RIVER WOOD COVE SUBDIVISION

APPLICATION NUMBER 17 DATE June 16, 2005
APPLICANT River Wood Cove Subdivision
REQUEST Subdivision

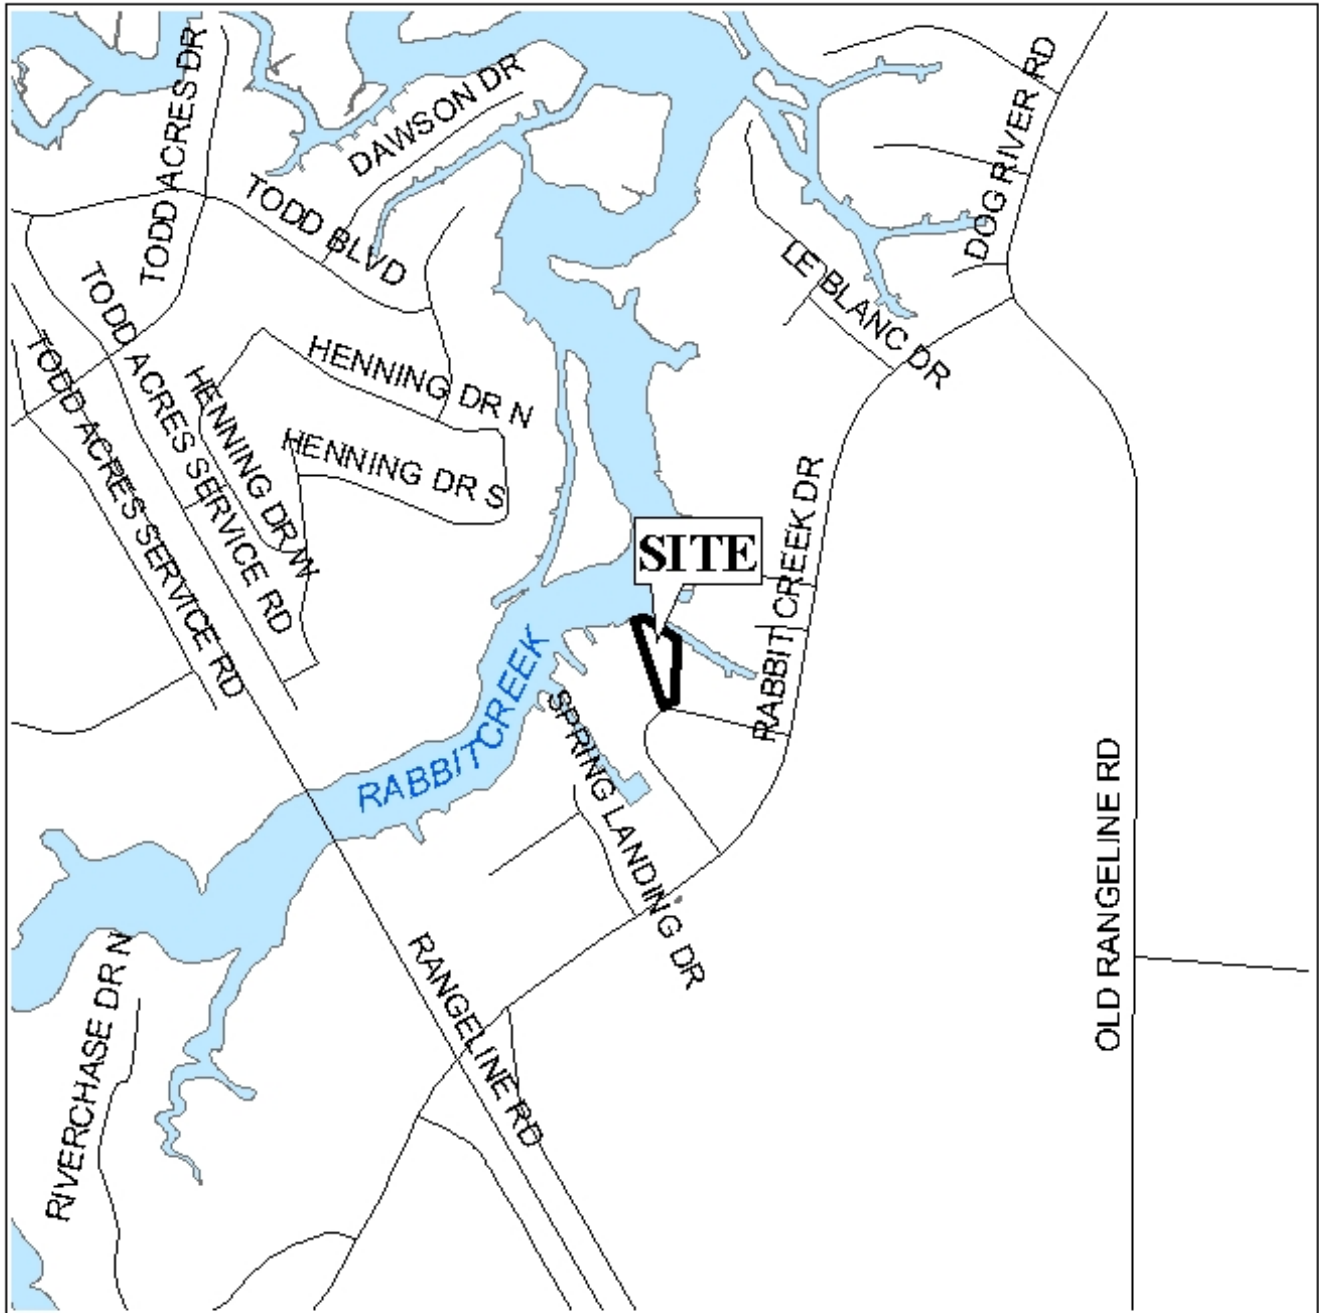
The site fronts Gulf Creek Circle, a minor street, which has a right-of-way width of 50 feet at this location. The minimum right-of-way width for a minor street lacking curb and gutter, such as Gulf Creek Circle, is 60 feet, or 30 feet in each direction as measured from the centerline of the roadway. Since the existing right-of-way does not meet the recommended minimum width for a minor street lacking curb and gutter, according to Section V.B.14. of the Subdivision Regulations, the setback of an additional 5 feet from the right-of-way should be required. Additionally, the 25-foot minimum building setback line depicted on the plat should be adjusted to reflect the recommended additional setback from the right-of-way.

The site is within the drainage basin for Rabbit Creek, a tributary to Dog River. The site appears to be partially located within floodplains associated with the creek. Furthermore, the relative flatness and low elevation of the general area indicates an increased potential for wetlands, which do occur near the site, and an increased potential for drainage problems during heavy rain events. The presence of wetlands and floodplains on and near the site indicate that the area may be environmentally sensitive; therefore, the approval of all applicable federal, state and local agencies would be required prior to the issuance of any permits.

The plat is recommended for Tentative Approval subject to the following conditions: 1) the setback of an additional 5 feet from the Gulf Creek Circle right-of-way, in conformance with Section V.B.14 of the Subdivision Regulations; 2) approval of all applicable federal, state and local agencies regarding the wetlands and floodplain issues prior to the issuance of any permits; and 3) placement of a note on the Final Plat stating that any lots which are developed commercially and adjoin residentially developed property must provide a buffer, in compliance with Section V.A.7. of the Subdivision Regulations.
